Re: 1005 Perkins Avenue, Waukesha, WI
FID #268091890

SUBJECT: Closure Request for the *Underground Storage Tank Case* and the *PCB Contaminated Soils Case* at the Perkins Avenue Facility Site,
1005 Perkins Avenue, Waukesha, WI

**PHASE III ENVIRONMENTAL ASSESSMENT
AND CONCEPTUAL ACTION PLAN**

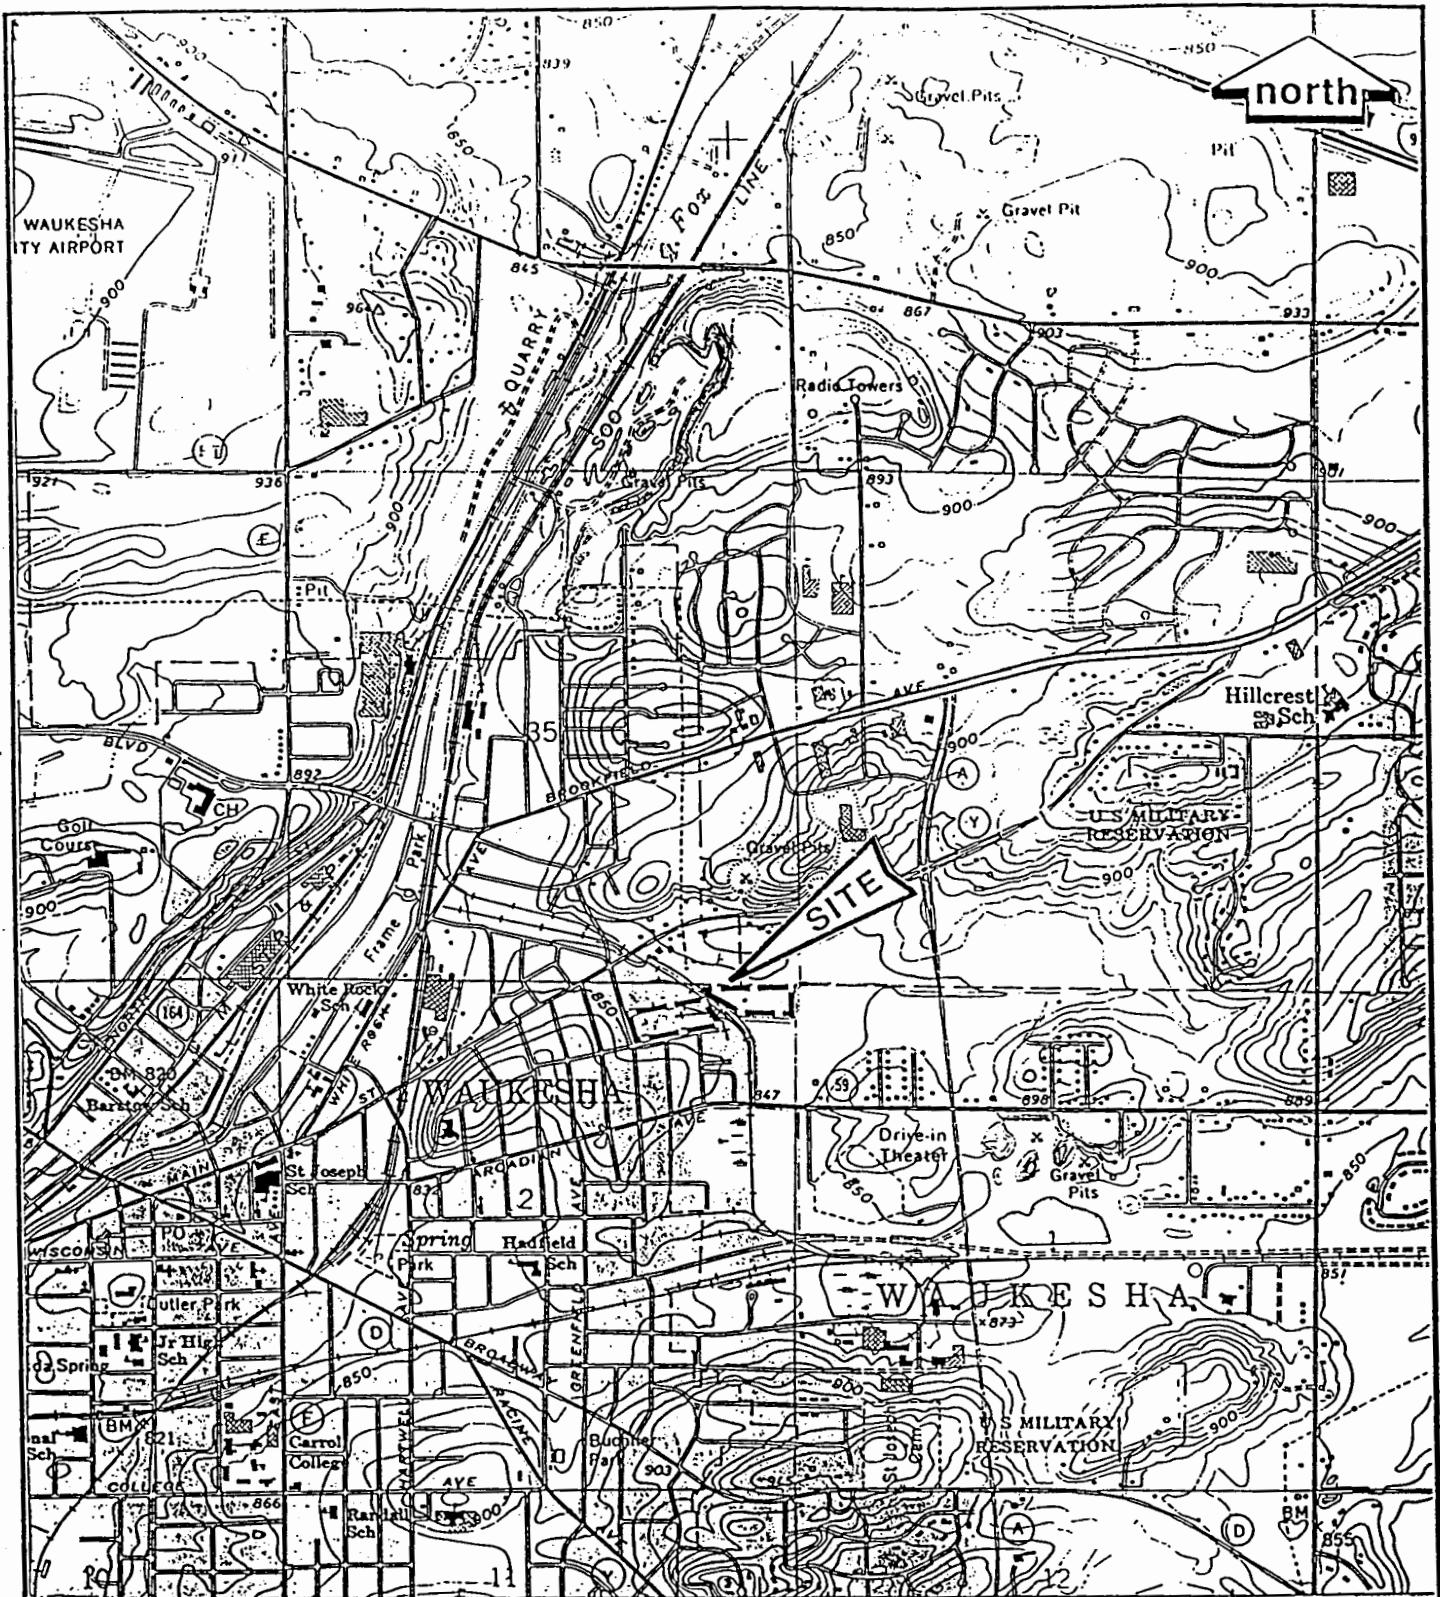
1. Page 4 of the report is a blank sheet of paper. The List of Figures indicated that the page should contain figure 2 which is the "site layout with sampling grid location". Please submit a copy of the figure.

The first item requested was a copy of Figure 2 from the Phase III Environmental Assessment and Conceptual Action Plan prepared by Versar dated November, 1993. Unfortunately, that was a fold-out page that was not unfolded at the time of photocopying. I am enclosing a copy of Figure 2 with this letter.
